PLANT NAME:
Nine Mile Point #2

Furnishing requested information regarding the revetment ditch system for Unit No. 2.

Re: Nine Mile Point Unit 2
Docket No. 50-410

Enclosed is information requested in your July 16, 1976 letter regarding the revetment ditch system for Nine Mile Point Unit 2. Five copies of this information are provided which responds to your questions 1, 2, 4, 5 and 6. Information responding to questions 3 and 7 will be submitted about September 28, 1976.

FIGURE 2
LAKE ERIE COMPUTATION GRID
AND BOTTOM DEPTHS
NINE MILE POINT NUCLEAR PLANT-UNIT 2
NIAGARA MOHAWK POWER CORPORATION

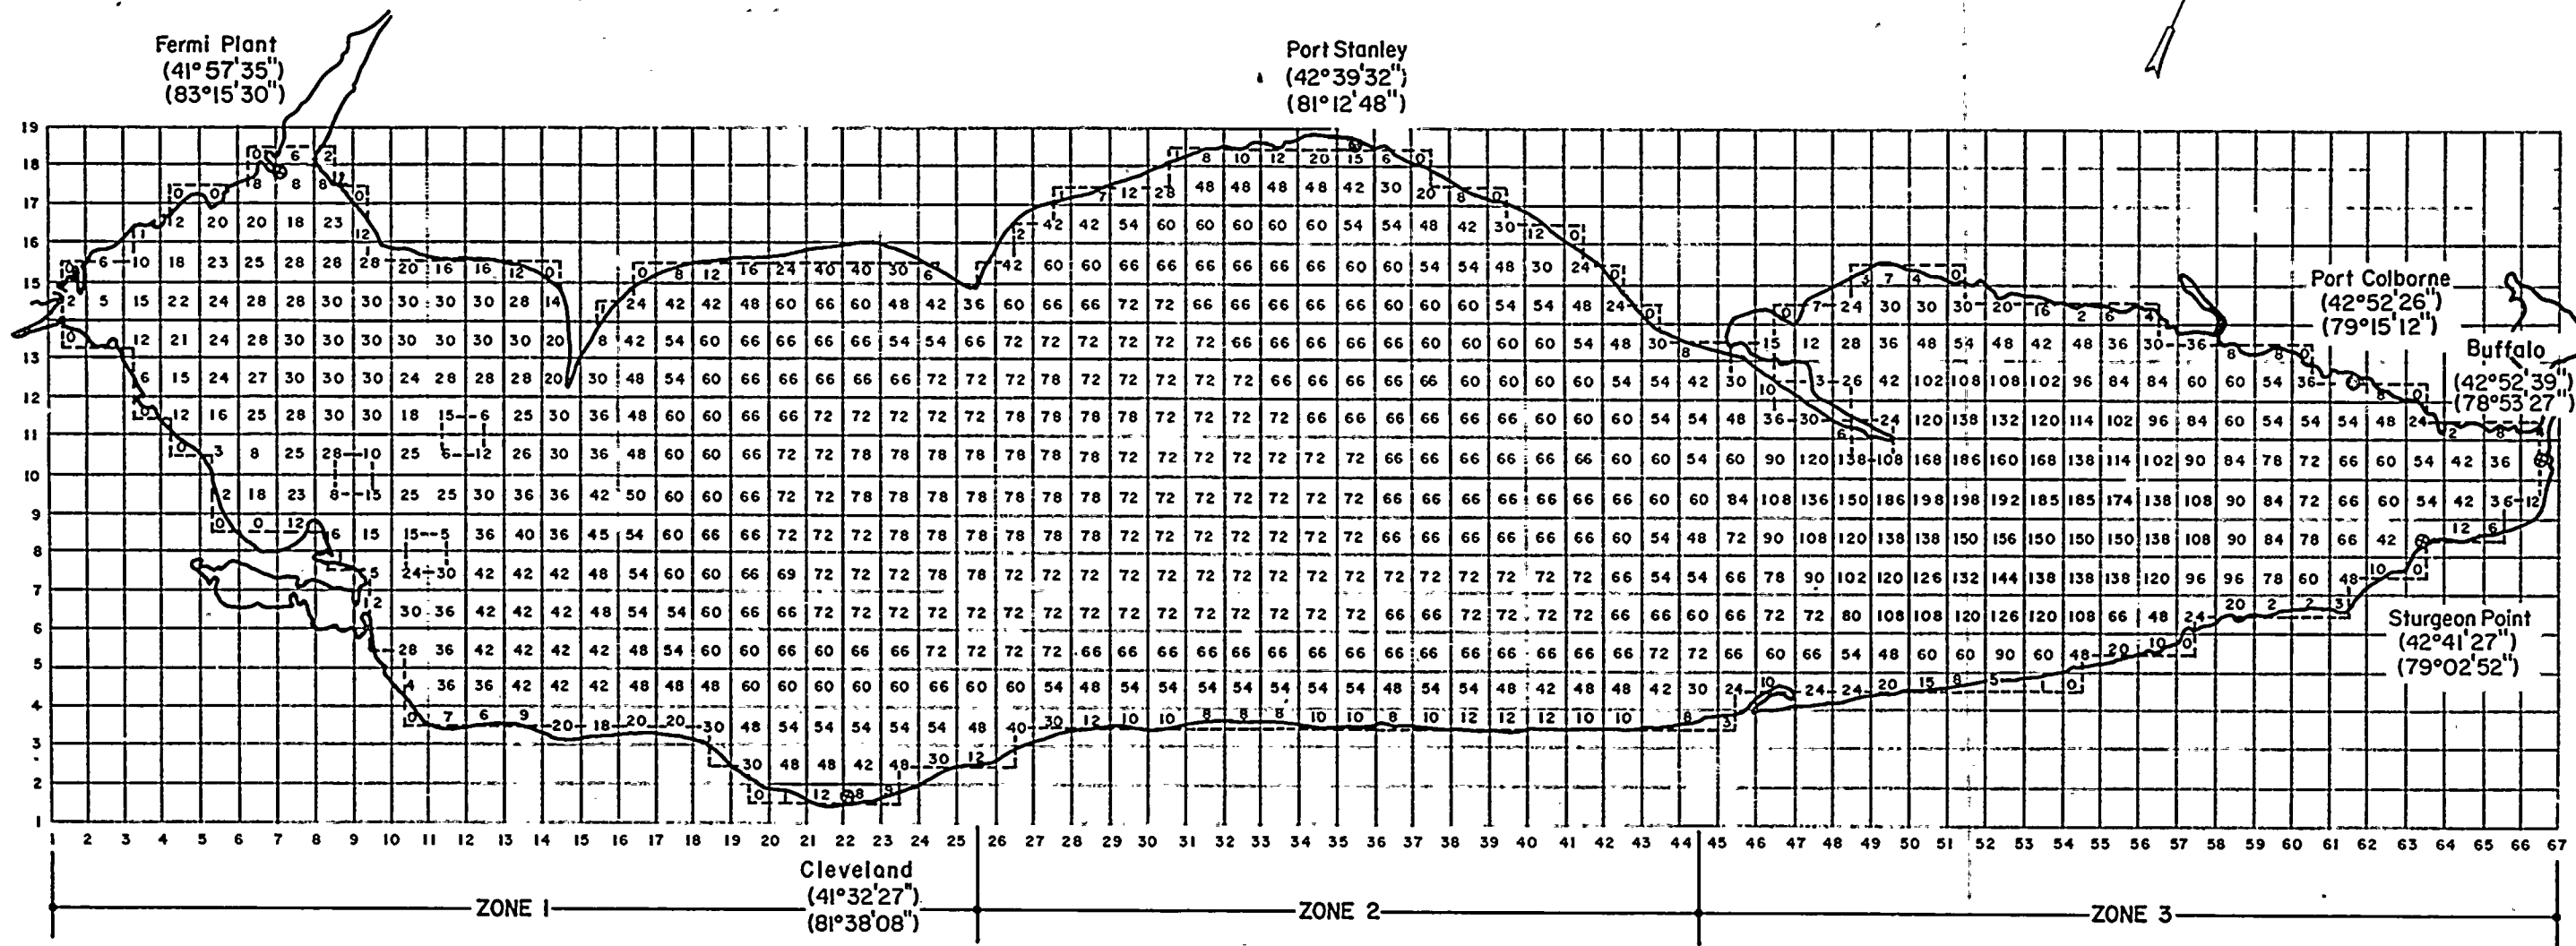
In addition, for verification studies include maps locating gage stations and grid points and depths where the surge was calculated.

Figures 1 and 2 show the computation grid, water depths and actual verification gage locations for Lakes Ontario and Erie, respectively. In the verification studies, the grid points nearest to the actual gage stations were selected and the calculated surges at these points were compared to the recorded surges at the gage stations. Tables 1 and 2 list gage stations, verification grid points, and water depths at each grid point for Lake Ontario and Lake Erie.

FIGURE 3
PREDICTED PROBABLE MAXIMUM
STORM SURGE AT PLANT SITE - CASE 1
NINE MILE POINT NUCLEAR STATION - UNIT 2
NIAGARA MOHAWK POWER CORPORATION

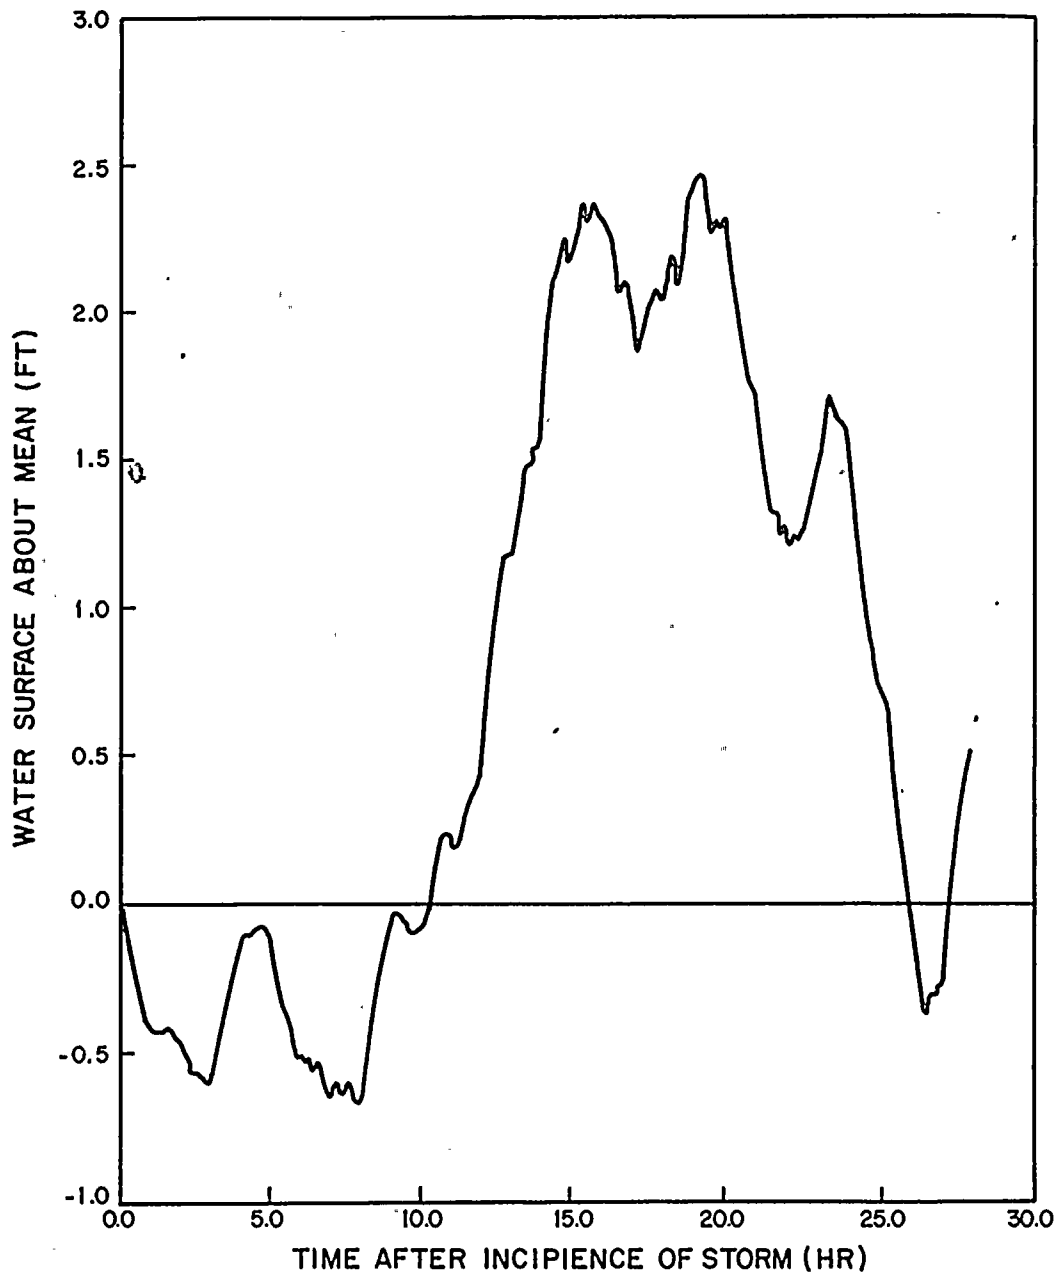
The model of the Probable Maximum Wind Storm used in the 1976 report is different from that used previously. How does the resulting storm surge at the site differ from that previously computed? Figures showing the predicted surge and a map with the computational grid, showing the location of the point where the surge was calculated, should be provided. The water depth used in the computations for the surge at the site should be stated (figure R2.34-4 is not clear in this regard).

The probable maximum wind storm (PMWS) surge of 2.35 ft based on a PMWS model developed using the January, 1972, storm was reported to NRC in the 1973 response to Request 2.34. (2) The surge hydrograph was presented in Figure R-2.34-12. Response 1 of this submission discusses the changes in the PMWS model. Section 2.2 of the 1976 report (1) describes the current PMWS model and its conservatism. The surge hydrographs for the new PMWS model for the cases in Table 2.2-4 of the 1976 report are shown in Figures 3 through 7.

By comparing Figures 3, 4, and 7 to Figure R-2.34-12, it can be seen that the new PMWS model generates surge with steeper rise, higher peak, and longer duration of high surge. The results indicate that the new PMWS model is more conservative than the old model. Figures 5 and 6 show the surges at the plant site for a 13 mph slow moving wind storm. The surges have a slower rise and longer duration of high surge reflecting the slow moving nature of the storm. In spite of some differences in shape among the sensitivity test cases, the variation of peak surges is very small as presented in Table 2.2-4 of the 1976 report.
